Well Name: AXI APACHE F	Well Location: T23N / R5W / SEC 13 / NWNW /	County or Parish/State: RIO ARRIBA / NM
Well Number: 6	Type of Well: CONVENTIONAL GAS WELL	Allottee or Tribe Name: JICARILLA APACHE
Lease Number: JIC78	Unit or CA Name:	Unit or CA Number:
US Well Number: 3003921041	Well Status: Producing Gas Well	Operator: DJR OPERATING LLC

Sundry ID: 2656672

Type of Submission: Notice of Intent	Type of Action: Plug and Abandonment
Date Sundry Submitted: 02/11/2022	Time Sundry Submitted: 07:55
Date proposed operation will begin: 02/11/2022

Plug and Abandonment Procedure
for
DJR Operating, LLC
AXI Apache F 6
API # 30-039-21041
NW/NW, Unit D, Sec. 13, T23N, R5W
Rio Arriba County, NM

Proposed **Wellbore Diagram**
DJR Operating, LLC
AXI Apache F 6
API # 30-039-21041
NW/NW, Unit D, Sec 13, T23N, R5W
Rio Arriba County, NM

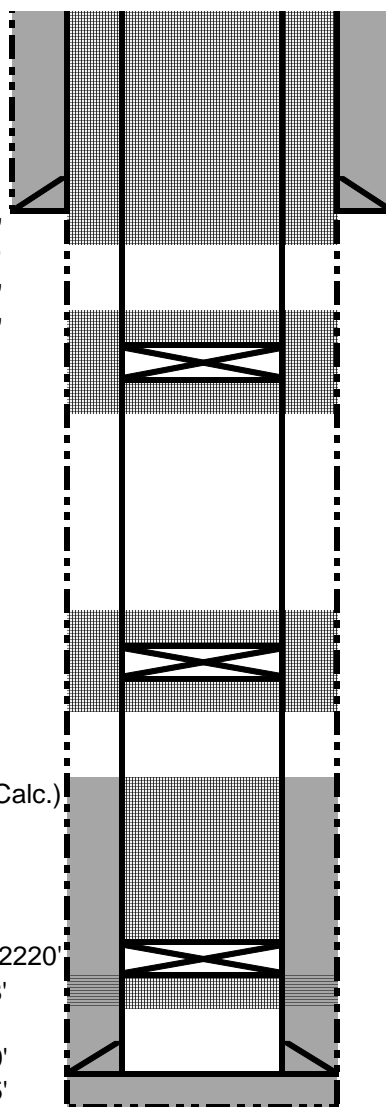
You are also required to place cement excesses per 4.2 and 4.4 of the attached General Requirements.

- The plugs proposed in the P&A procedure will adequately protect any freshwater sands in this well bore.
- Pictured Cliffs perms 2236' – 2288'.
